**GARRETT COUNTY COMMUNITY COLLEGE
STEM BUILDING 200**

ADDENDUM #2

TO THE CONTRACT DRAWINGS AND SPECIFICATIONS FOR THE REFERENCED PROJECT, BID SET, DATED FEBRUARY 1ST 2017, AS PREPARED BY GRIMM AND PARKER ARCHITECTS, 11720 BELTSVILLE DRIVE, SUITE 600, CALVERTON, MD 20705.

A-3.2
February 1, 2017
Bid Set

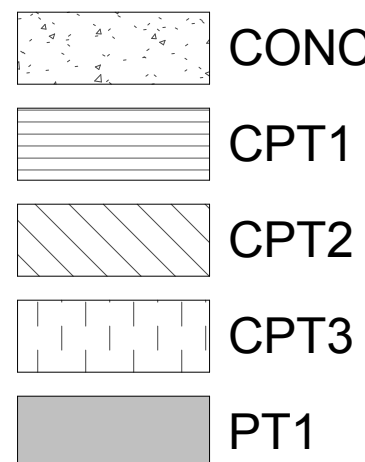
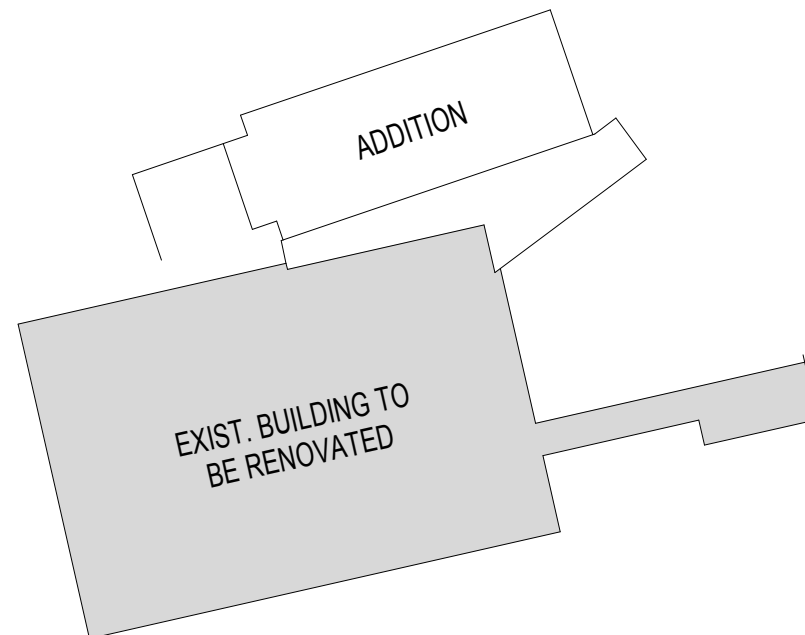
REVISE Flooring material at south entry Vestibule 200A to be PT1. Owner will provide removable roll-out mats on top of porcelain tile. CPT4 has been removed from the project. (see attached drawing)

M-2.1

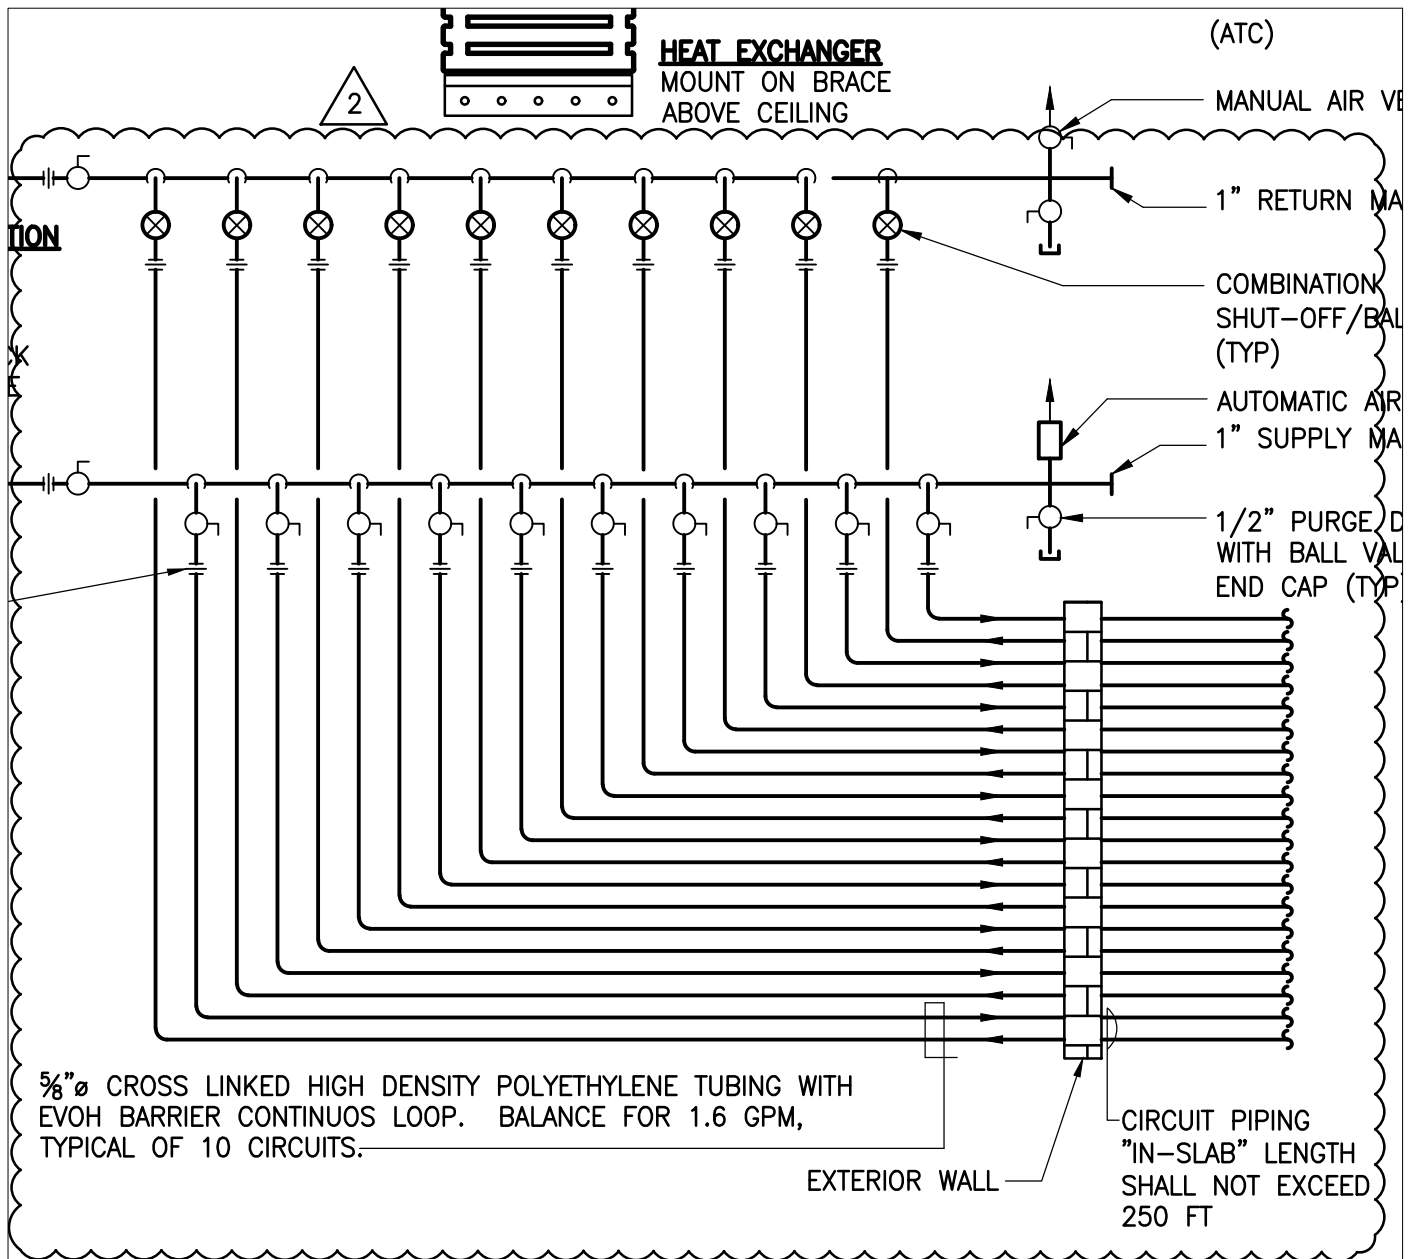
REVISE Piping diagram has been revised. Refer to sketch M-2.1 for additional information.

ADD
M-2.3

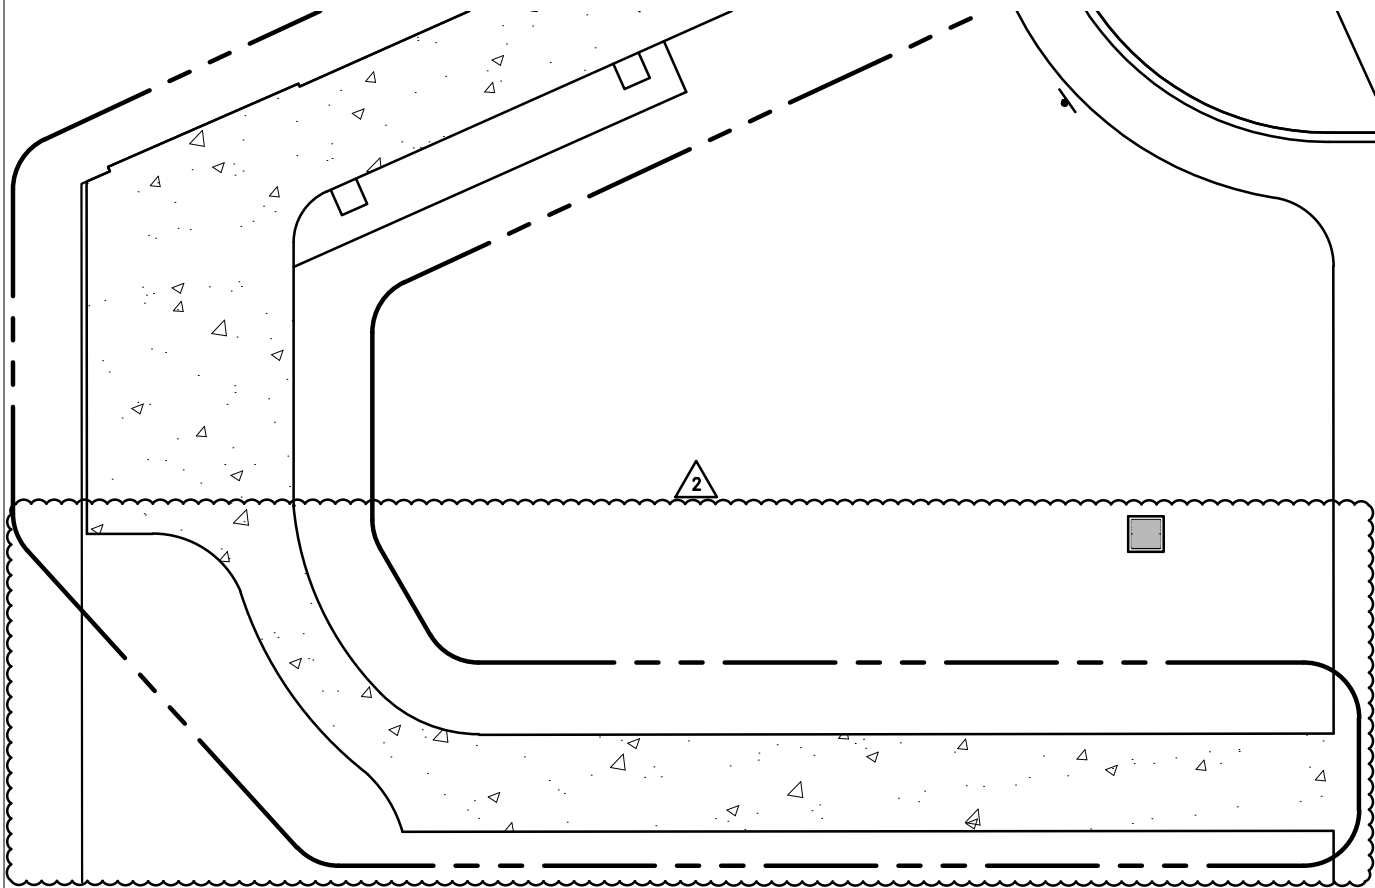
REVISE Part plan has been revised to include the sidewalk leading to the entry of building 300. Refer to sketch M-2.3 for additional information.
